Contract #: 04-0120F4Cty: SF/ALA Rte: 80 PM: 13.2/13.9File #: 69.25B**QUALITY ASSURANCE -- NON-CONFORMANCE REPORT****Location:** Changxing Island, Shanghai, PRC**Report No:** NCR-000355**Prime Contractor:** American Bridge/Fluor Enterprises, a JV**Date:** 15-Jul-2009**Submitting Contractor:** Zhenhua Port Machinery Company, Ltd (ZPMC), Changxing Island**NCR #:** ZPMC-0329**Type of problem:**

Job Name: SAS Superstructure

Subject: NCR No. ZPMC-0329

Reference Description: Missed UT Indications

Draft of welding discontinuity:

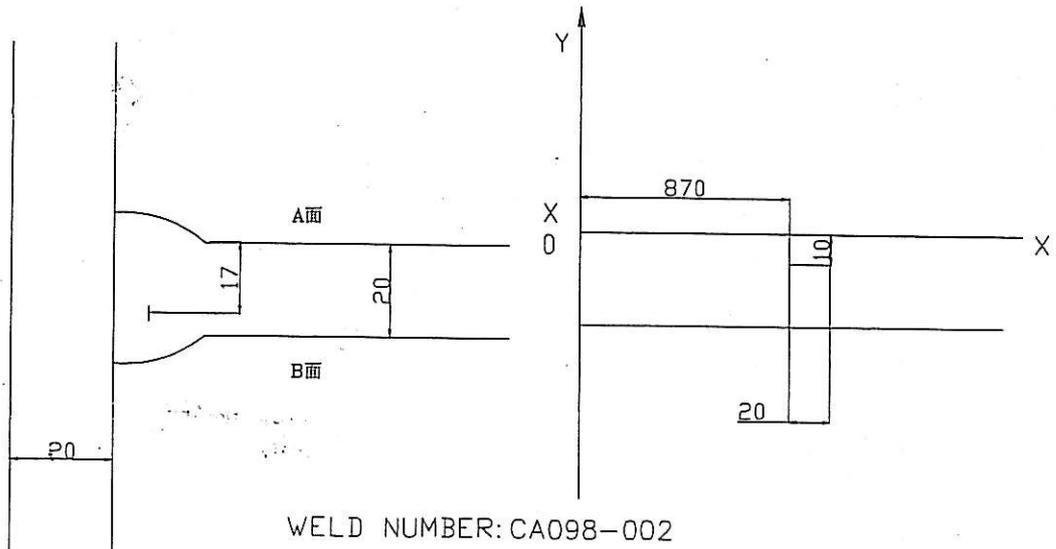
Description of welding discontinuity:

Rejected indication found by ultrasonic inspection is less than the maximum allowance aggregate length.

(UT探伤发现的缺陷总长度小于最大允许长度。) CA098-002

- 1、焊道未及时处理干净。
1. Did not clear the weld pass completely in time.

1. 从缺陷距离端面较近一侧 ($D \leq 0.65T$, D为缺陷深度, T为板厚) 采用碳刨或打磨的方法去除焊缝缺陷;
2. 参照返修焊接工艺规程 (WPS) 准备正确的接头型式, 预热和焊接;
3. 焊前对修补区域进行VT检测保证缺陷完全被清除;
4. 将修补区域打磨到与母材或邻近焊缝平齐;
5. 根据批准的车间图纸检查焊缝.

1. Gouge or grind from nearer side from metal edge ($D \leq 0.65T$, "D" is depth of defects, "T" is thickness of metal) to remove all defects;
2. Follow repair WPS for joint preparation, preheat, and weld deposit;
3. Verify with VT no defects remain in the weld joint prior to welding;
4. Grind the repaired area flush with base metal or the adjacent weld;
5. Check the welds according to the working drawings.
